Copy of letter from Dr. Jopp, Engineer, Procurement Engineer, Panama, to the Superintg. Engineer
 VI Circle No 1465 dated 19th June 1889

17/9 I have the honor to submit the report on the Light House at Pambou as requested in your letter No: 1067. J. & of 26th February 1889.

Lighthouse at Pamban.

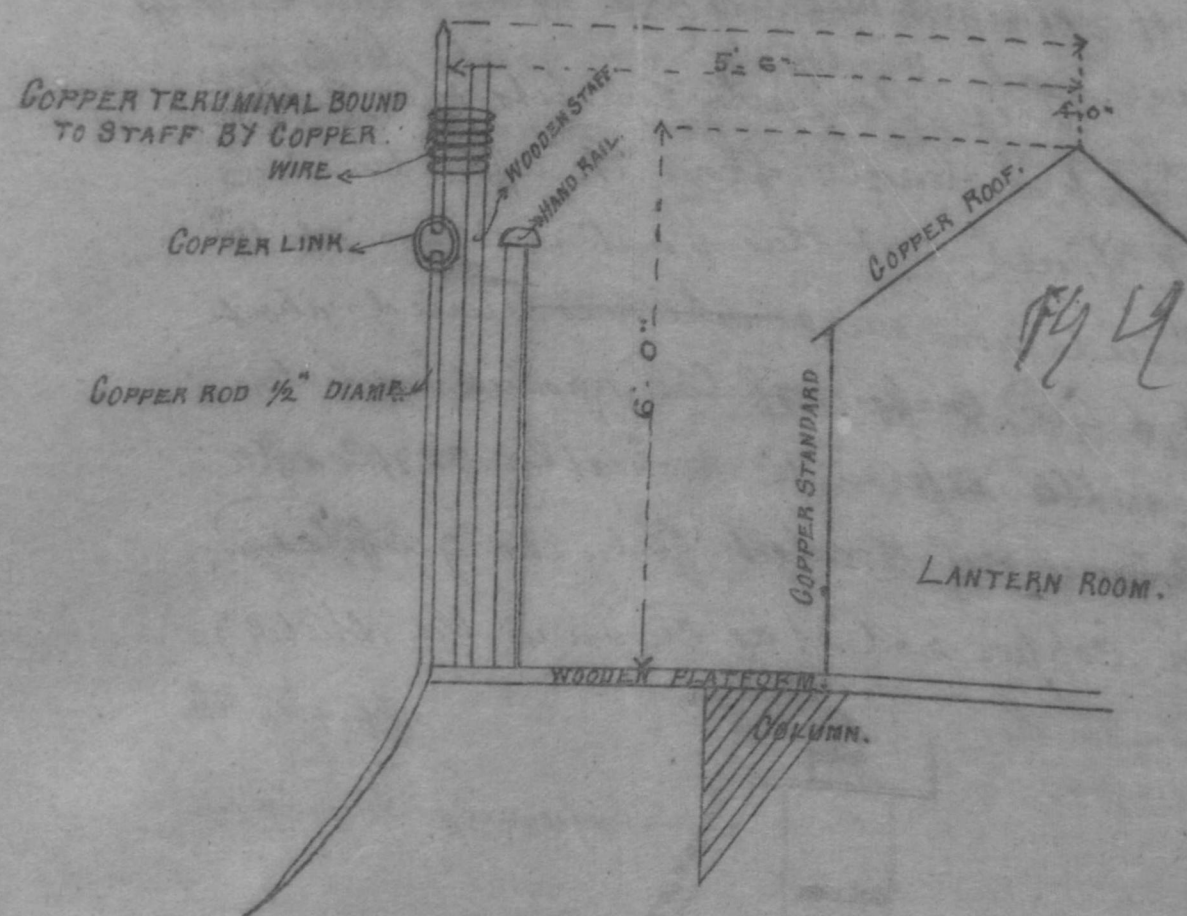
4. (a). The Conductor consists of a Copper rod 76 feet in length from its upper terminal to ground level; at this point it is joined to a galvanised iron wire, which is buried about 1 foot below the surface of the ground and terminates near the sea in permanently moist earth at a distance of 215 feet from its junction with the Copper rod (as shown in the sketch)

The soil at the base of the Column and throughout the length of the iron wire is pure sand and quite dry.

(b). The diameter of the Copper rod is a little less than $\frac{1}{2}$ an inch which may be considered sufficient but the diameter of the iron wire is only $\frac{1}{3}$ of an inch and as it passes for 215 feet through an almost non conducting medium of dry sand, its diameter should be at least $\frac{1}{2}$ inch.

(c). Again the junction between the Copper rod and iron wire is electrically inefficient.

The iron wire is merely twisted tightly several times round the Copper rod and as the wire is also considerably rusted, the junction cannot be said to be electrically a safe one.

(d). The upper terminal is not jointed and soldered to the Copper rod but is merely connected to it by a copper link as shown in the

(e). There is a considerable mass of metal, chiefly Copper, in the roof and frame work of the lantern room. This is not connected with the Conductor; the upper terminal of which is not more than 4 feet higher than the top of roof and at a horizontal distance of about 5'-6" from it.

(f). There is no metal plate at the lower terminal of the Conductor.

5. In order to render the Conductor efficient I think it would be necessary.

1st To replace the iron wire by a Copper rod of $\frac{1}{2}$ " diameter.

2nd To properly joint and solder the Conductor to its upper terminal.

3rd To connect all metal of the roof and frame work of the lantern room to the Conductor.

4th To provide a metal plate of sufficient size at the lower terminal.
